Access Compliance Report

Public Rights-of-Way

(Curb Ramps)

Intersection ID: 9543	Main Street: W_30TH_ST	Cross Street: BELLEFONTE_DR	Location: SW
ADA ID: 5178FC2EE692	Ramp Type: PerpDiag	Initial Pass/Fail: Fail	Overall Compliance: No
		Severity Score: 10

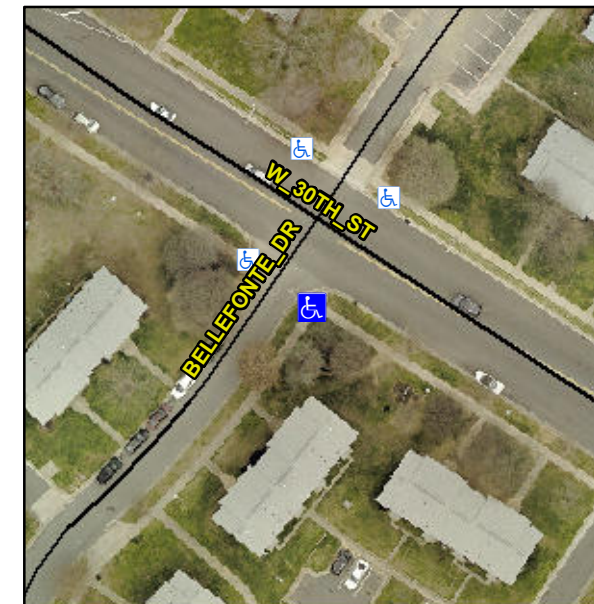
Not Found, R304.5.1, R304.5.3

Remove & Replace Curb Ramp With Two New Directional Ramps or Equivalent.
